Stratford Renewable Energy Hub Submissions Report

The proposed Stratford Renewable Energy Hub would comprise a Pumped Hydro Energy Storage (PHES) with an indicative generation capacity of 3.6 gigawatt-hours (i.e. 300 megawatts [MW] over 12 hours), alongside a complementary photovoltaic solar farm facility (Solar Farm), collectively referred to as 'the Project'. The Solar Farm would have an indicative capacity of approximately 320 MW alternating current (equivalent to 375 MW direct current), to supply a portion of required energy to 'charge' the PHES.

In response to submissions received on the EIS, Yancoal has prepared this Submissions Report to provide an analysis of the submissions received, summarise the actions taken since lodgement (including additional engagement activities, further assessments and proposed refinements), and provide responses to issues raised and an updated evaluation of the Project.

Figure 4-8

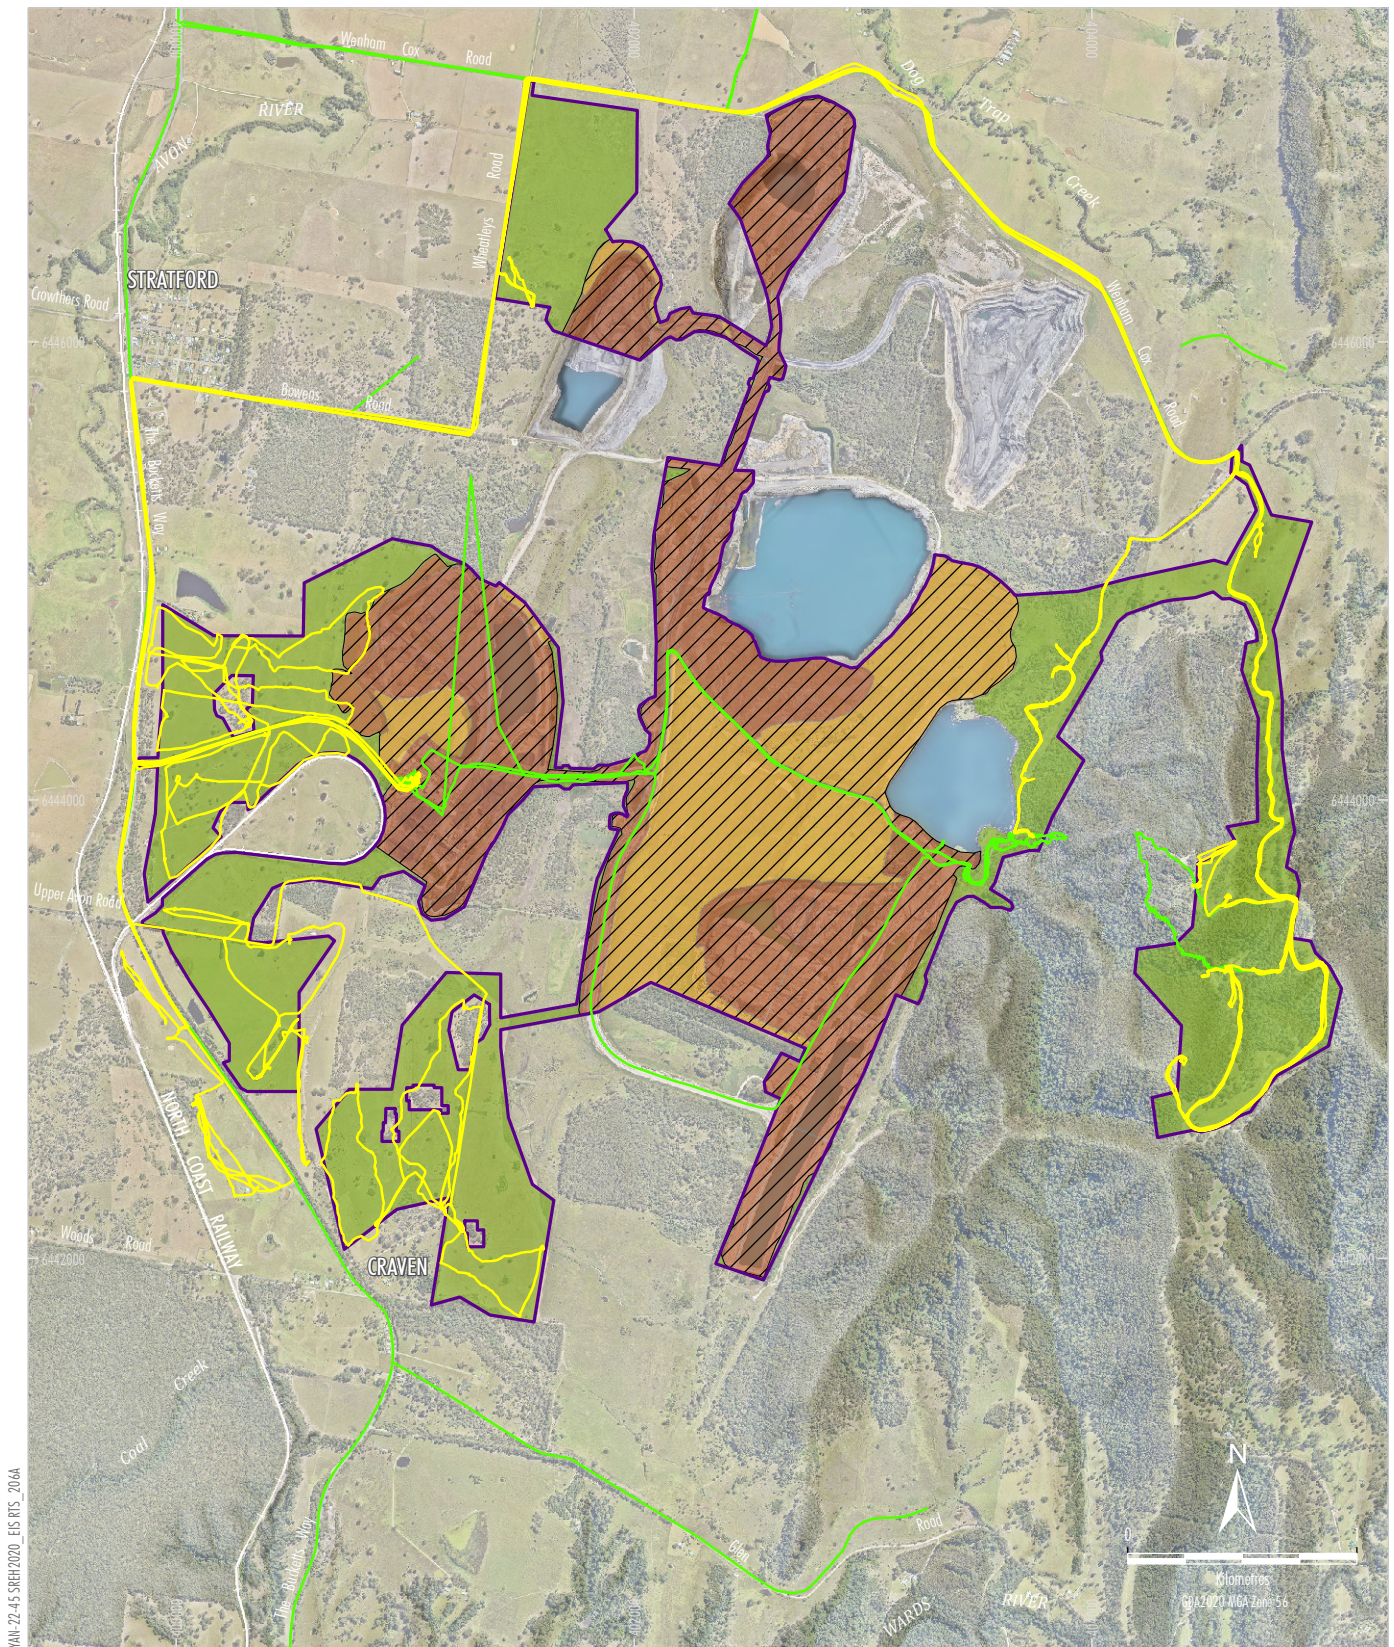
8. *Additional survey may be required for the Upper Reservoir. The survey track logs presented in Figure 8 of the ACHAR appear to be heavily constrained along the access tracks and less so in the bushland where there will be large scale excavation works.*

It should be noted that the survey tracks shown on Figure 4-8 (as presented in the ACHA [Niche, 2024a]) only represents one of the six survey participants survey coverage. When considering all six participants, the breadth of the survey corridor broadens. Additionally, this area was surveyed previously for the Stratford Mine Exploration Clearance Letter (Niche, 2023), with the targeted inspection (Plate 4-12) identifying no archaeological material (Attachment 11), further justifying the low archaeological potential of the Upper Reservoir.

Plate 4-13: Figure 9-1 of the BDAR

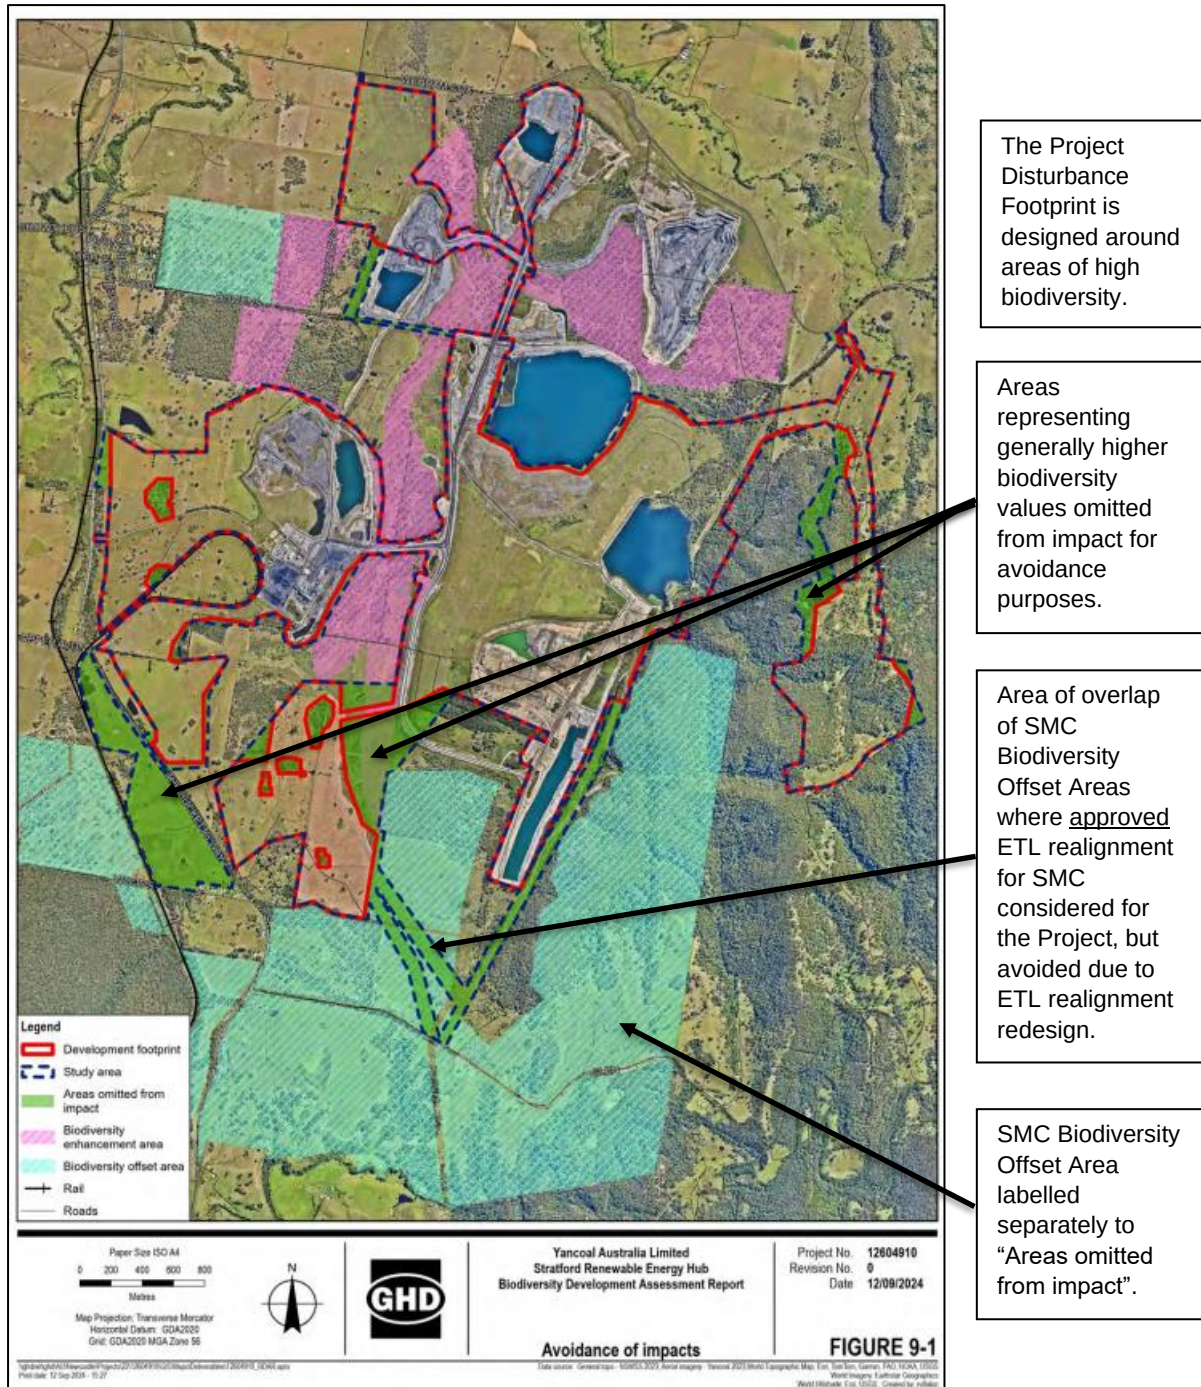
Along with this, the BDAR also lists avoidance of areas that are part of the offset strategy for the existing consent (SSD 4966). Figure 9.1 – Avoidance of impacts depicts areas of avoidance as part of the previous offset strategy. This cannot be considered as part of the new application as this was intended to offset the previous impact. The BDAR must clearly distinguish between the previous offset strategy and measures proposed to offset the impacts of the proposed project.

It is incorrect for CPHR to state the Project includes existing SMC Biodiversity Offset Areas as part of its avoidance strategy. The SMC Biodiversity Offset Areas are shown on Figure 9.1 of the BDAR (repeated below as Plate 4-13), along with other regional features such as roads and railways. It is a statement of fact that the Project Disturbance Footprint is outside the existing SMC Biodiversity Offset Areas; these areas are shown to provide context to the BDAR reader as to why the Project Disturbance Footprint is shaped the way it is. "Areas omitted from impact" are separately shown on Plate 4-13, and these areas are those that have been avoided through the iterative Project design, as they are generally associated with areas of relatively higher biodiversity value.
